January 18, 2002

Blue Bird Body Company has determined that a defect, which relates to motor vehicle safety exists in certain 1999 through 2002 model year Blue Bird All American and TC/2000 school and transit buses and Q-Bus and Commercial Series transit buses. Blue Bird is conducting a recall to correct this defect.

RECALL R01FL INSTRUCTIONS
FASTENER REPLACEMENT ON HENDRICKSON REAR AIR RIDE SUSPENSION

TORQUE ARM FASTENER REPLACEMENT INSTRUCTIONS

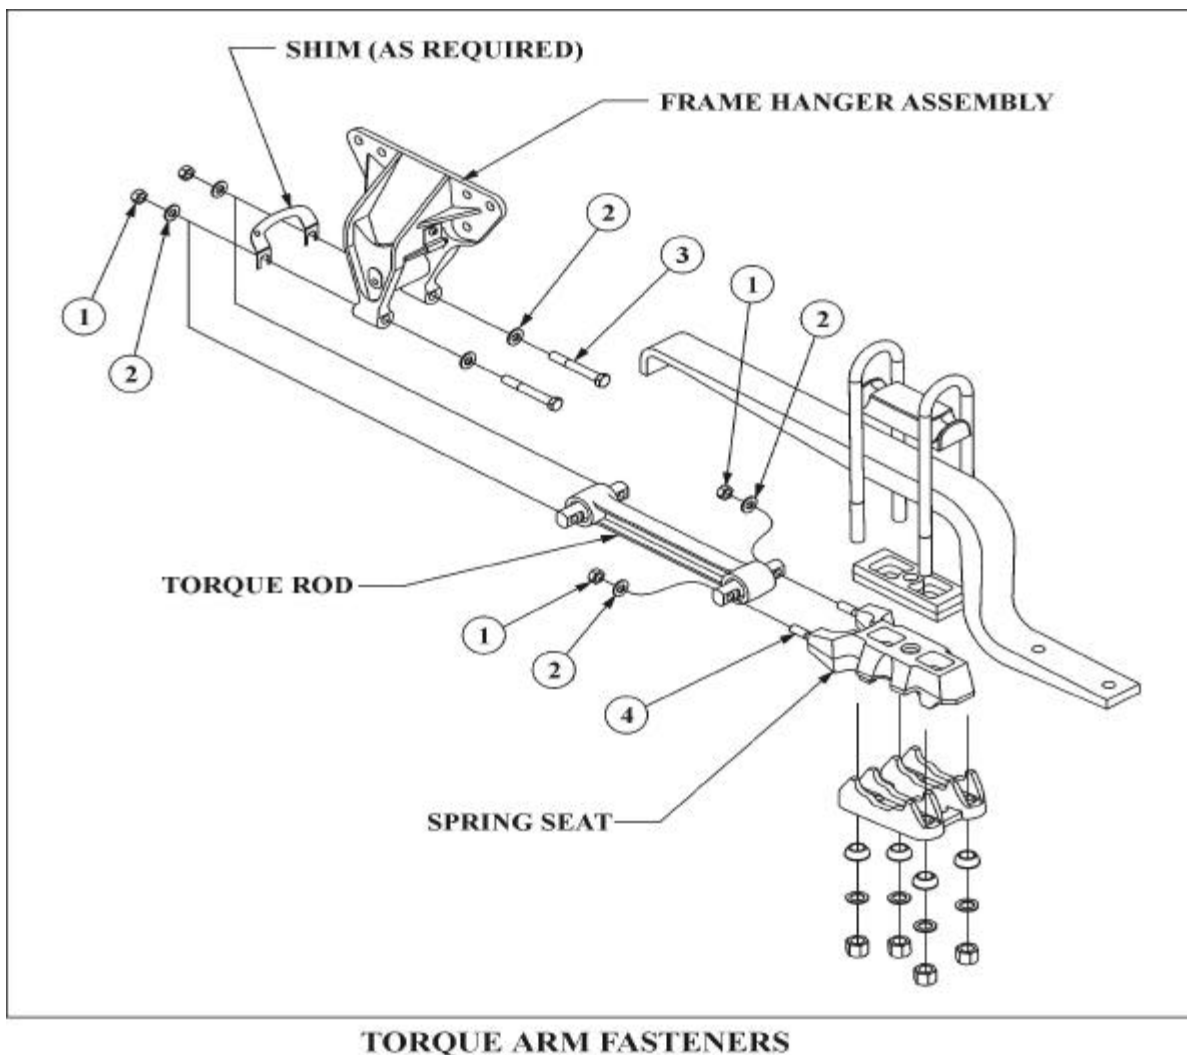
1. On the left side Hendrickson rear air suspension, remove the torque rod fasteners (Items 1, 2, and 3) that attach the torque rod to the frame hanger assembly. See drawing on page 2. Note: If a torque rod shim(s) has been installed, note location, remove and keep. Remove the lock nuts (Item 1) and flat washers (Items 2) that attach the torque rod to the spring seat. Remove and keep torque rod. Discard all fasteners.

2. A kit will be supplied containing the required fasteners for both sides of the suspension. The kit contains twelve (12) 5/8" hardened flat washers, four 5/8"-11 UNC Hex Head bolts 4.5" long, eight 5/8"-11 UNC lock nuts, and four 5/8" studs.

3. Remove and discard the two 5/8" studs (Items 4) in the spring seat bracket and install two new studs by following the instructions on page 11 in **Hendrickson Tech Pub** under **SPRING SEATS** in the **Component Replacement Section**.

4. Install torque rod onto spring seat studs. Install two new 5/8" hardened flat washers (Item 2) and two new lock nuts (Item 1) onto spring studs. Hand tighten locknuts.

5. Position torque rod against frame hanger assembly. Install two 5/8" torque rod bolts (Item 3) and two hardened flat washers (Item 2). Install two lock nuts (Item 1) and two flat washers (2) onto bolts. If a torque rod shim(s) had been removed, re-install in the same position as originally installed. Torque these bolts and the locknuts for the spring seat studs to 150-205 ft. lbs.
6. Repeat above procedure on right side of Hendrickson rear air suspension.

INSTRUCTIONS FOR REPLACING SPRING SEAT (IF REQUIRED)

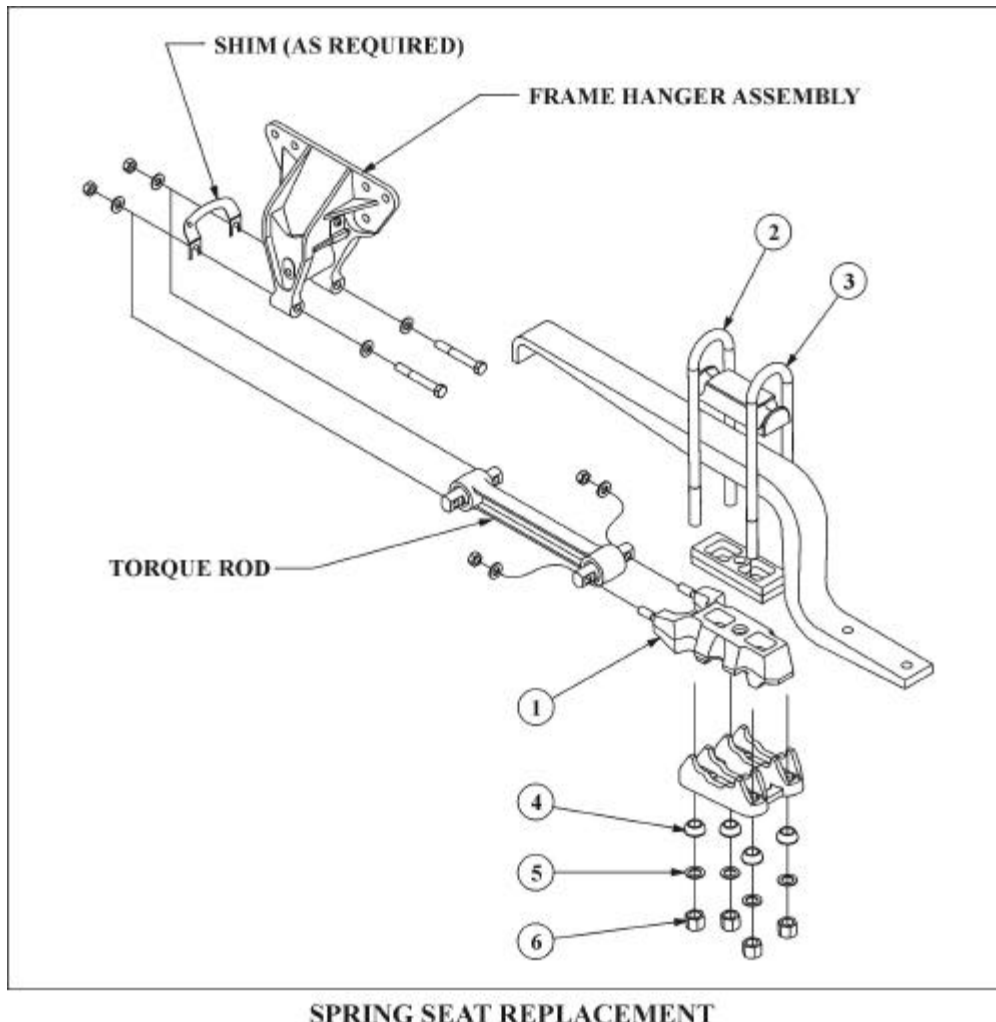
Contact Bill Coleman at Blue Bird at 478-822-2242 for the correct spring seat (Item 1).

Note: Provide Bill Coleman with Blue Bird body number for the vehicle along with the Hendrickson part number, if legible. Hendrickson part number is painted across the spring seat. (Reference **Hendrickson Tech Pub** page 11 figure 13)

1. New u-bolts (Items 2 and 3), spherical washers (Item 4), flat washers (Item 5), and u-bolt nuts (Item 6) will be supplied with a new spring seat (Item 1). Discard all removed u-bolts, washers and nuts. **DO NOT REUSE**.
2. Follow the instructions in **Hendrickson Tech Pub** under **SPRING SEATS** in the **Component Replacement Section** page 11 for spring seat replacement and installation of new U-bolts. Torque per instructions found on the back page of **Hendrickson Tech Pub**.
3. Recommend that the drive axle alignment be checked after replacing spring seat. Rear axle alignment specifications are 0 to ¼” of center using laser alignment equipment.

FRAME HANGER ASSEMBLY BOLT REPLACEMENT

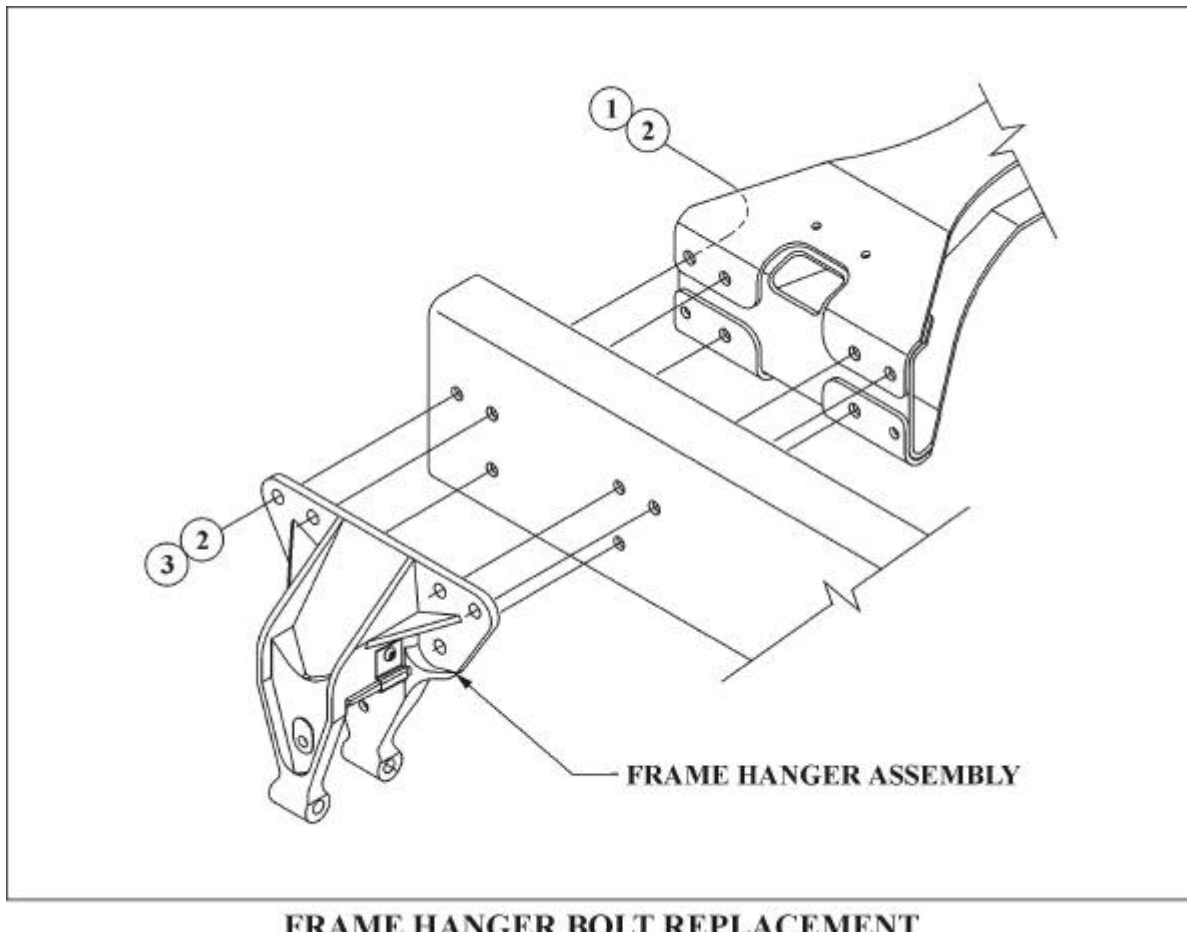
Caution: Wires and tubing may need to be moved to reach bolt heads with socket. Take the necessary steps to protect all wiring and tubing.

1. On the rear suspension left frame hanger assembly (it is recommended to replace two bolts at the time), remove and discard the six 5/8" bolts (Item 1), twelve hardened flat washers (Item 2), and six 5/8" locknuts (Item 3) shown in the illustration. Install six new 5/8" Class L9 bolts (Item 1), twelve Class L9 washers (Item 2), and six Class L9 locknuts (Item 3). Torque (by nut) to 205-ft. lbs.
2. Repeat on right frame hanger assembly.
